# Riverside Energy Park

## Applicant's response to Greater London Authority Deadline 3 Submission

**8.02.35**

July 2019 | Revision 0 (Deadline 4)

Figure 1: Policy Compliant Scenario

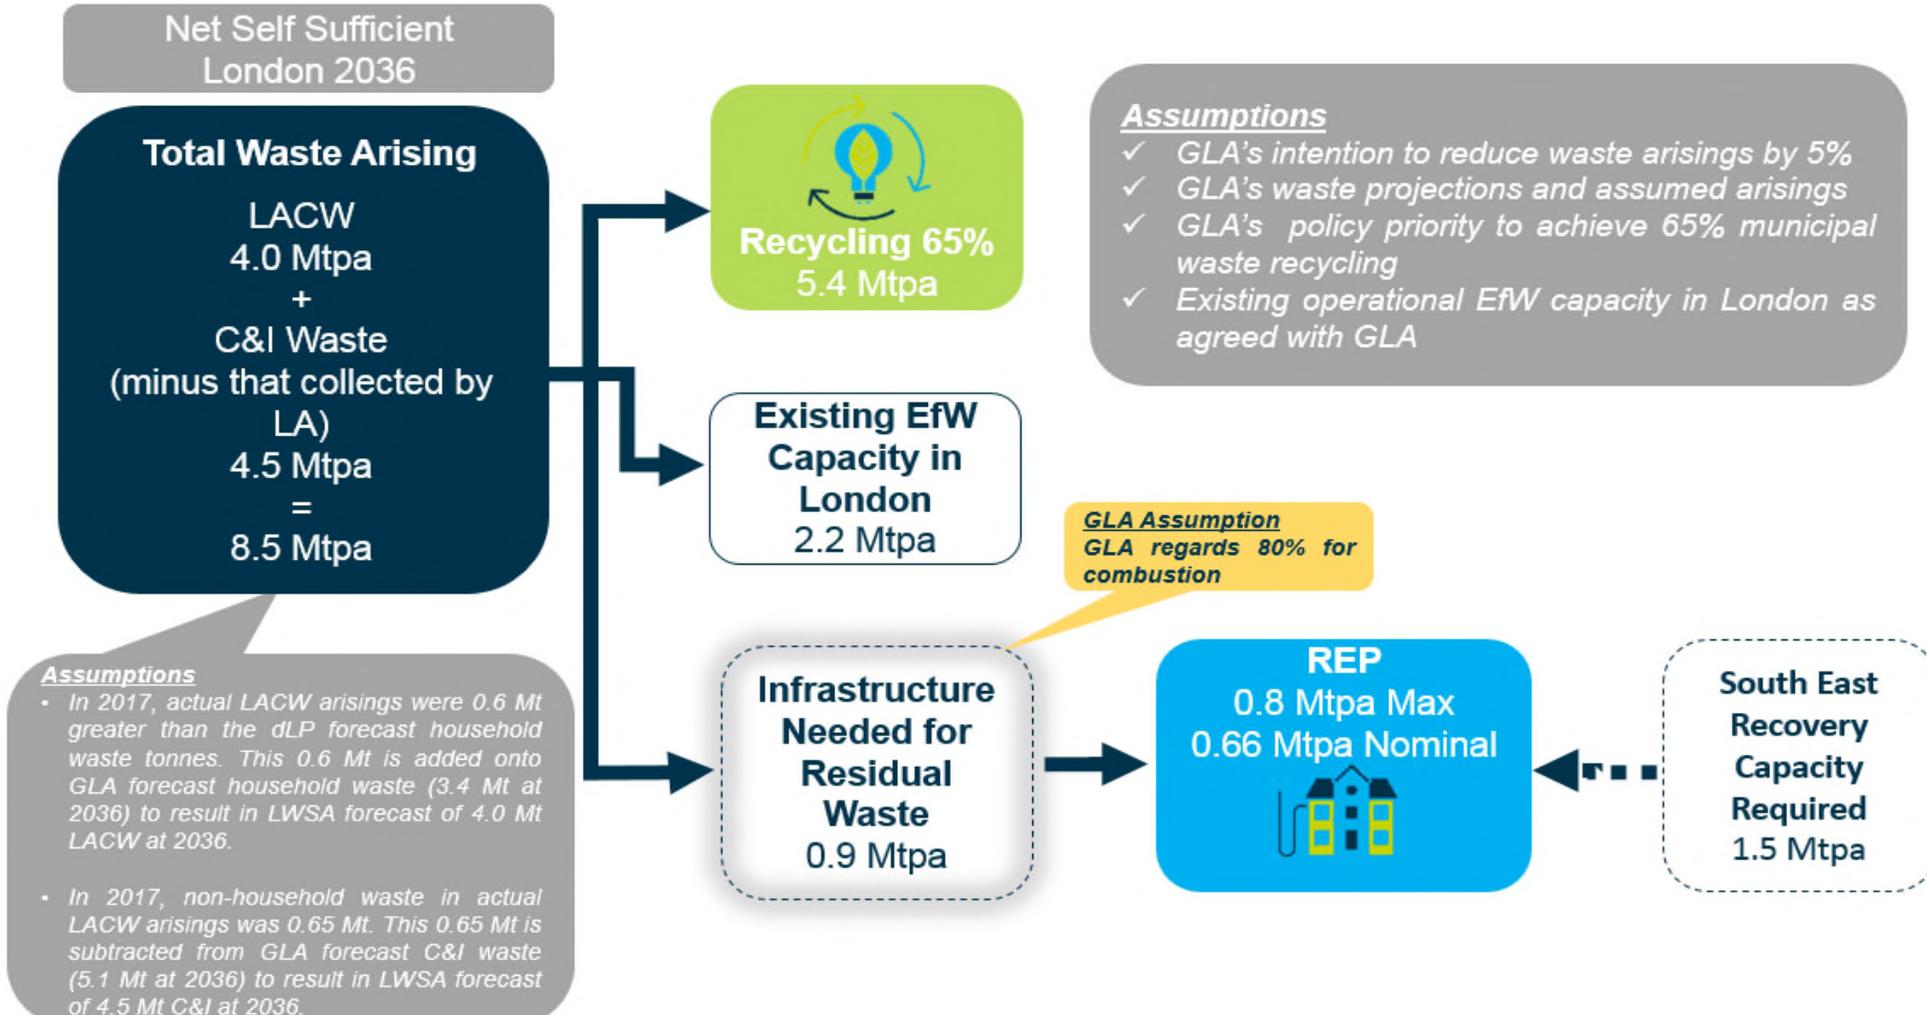
- 2.1.13 This is presented in **Figure 1**, which presents the draft London Plan Scenario 3b of the **LWSA** (presented in detail from **Paragraph 4.3.5** of the **LWSA (7.2, APP-103)**).

- 2.1.16 Consequently, total municipal waste arisings forecast to be generated in London are just under 8.5 million tonnes in 2036 (see **Table 4.5, row c** of the **LWSA (7.2, APP-103)**). This is presented in the blue column within **Figure 1**. As a result of the Applicant updating household waste to actual LACW and consequently subtracting non-household waste from the C&I arisings, the total municipal waste arisings forecast to be generated in London presented by the Applicant in Scenario 3b are 54,000 less than as forecast within the draft London Plan.

- 2.1.17 Scenario 3b then assumes that 65% of municipal waste will be recycled (from 2031, in accordance with LES targets<sup>4</sup>. Achieving this level of recycling treats just under 5.4 million tonnes in 2036 (see **Table 4.5, row h** of the **LWSA (7.2, APP-103)**), leaving just over 3 million tonnes (see **Table 4.5, row m** of the **LWSA (7.2, APP-103)**) of residual wastes in 2036. This is presented in **Figure 1**.

Figure 2: How REP contributes to the Waste Hierarchy

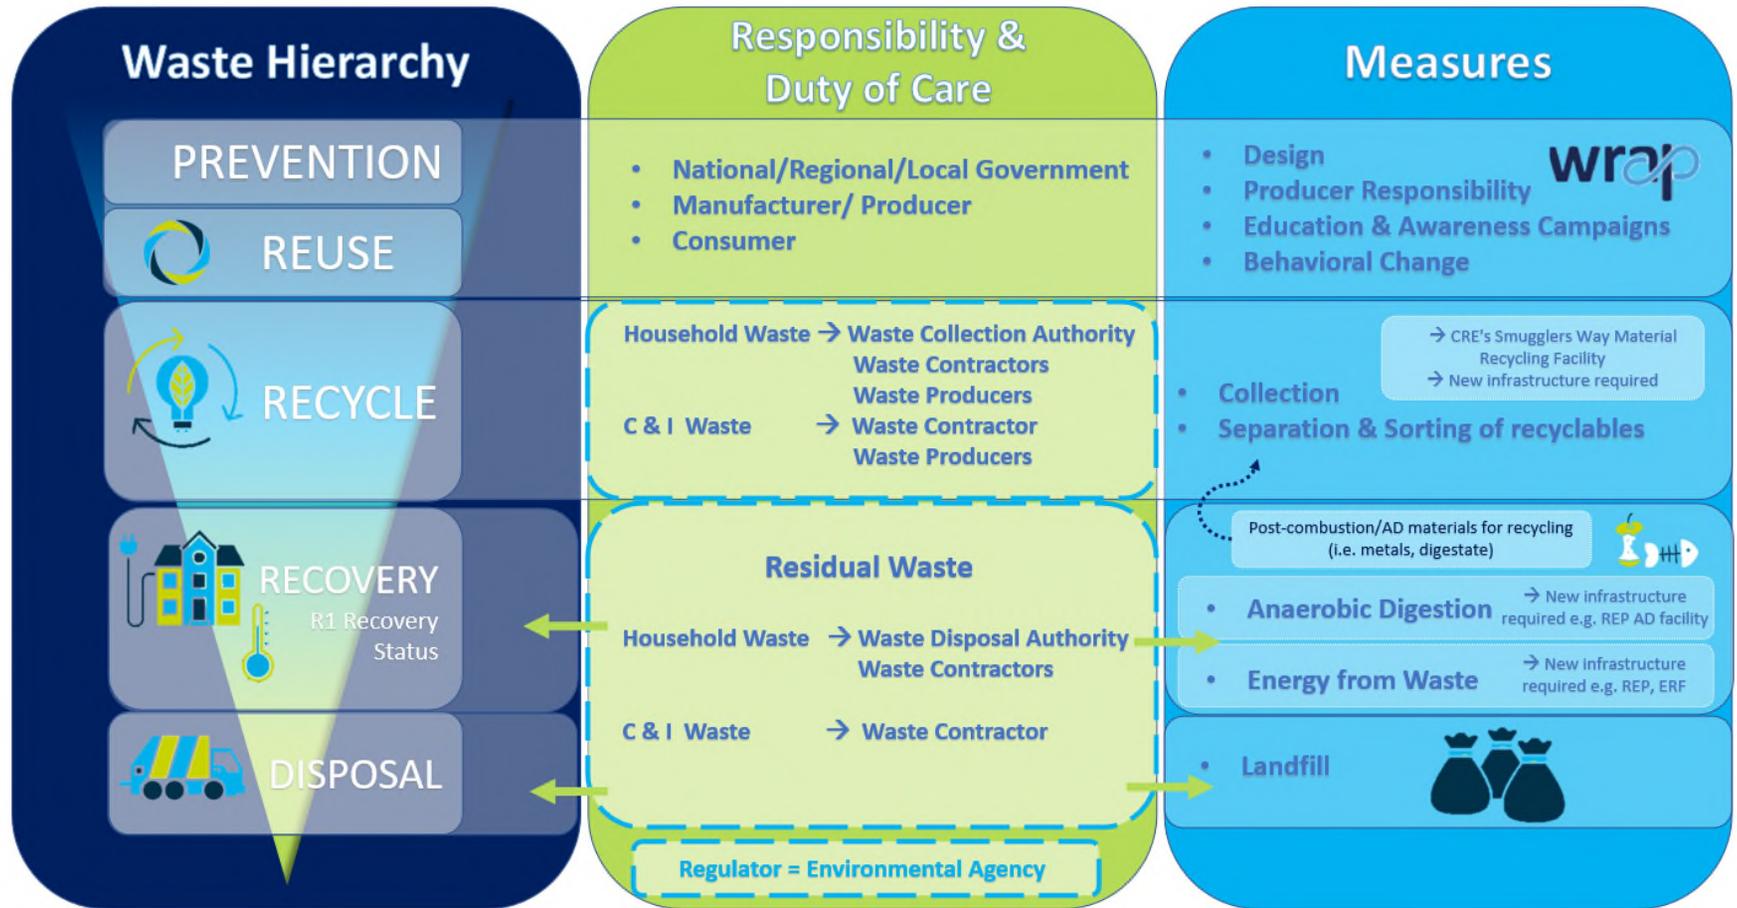
3.1.3 The **LWSA (7.2, APP-103)** demonstrates that delivering the waste hierarchy in London (reducing waste arisings over time and achieving 65% recycling) there remains a need for new energy recovery capacity to divert remaining wastes from landfill. The new recovery capacity proposed at REP will complement the Circular Economy, working alongside recycling activities in London in line with the waste hierarchy as illustrated in **Figure 2**.

- 3.1.8 **Figure 2** demonstrates the role of Riverside Energy Park (REP) in the waste hierarchy and how it is just one element of the overall infrastructure network needed in London to ensure that waste is managed appropriately.
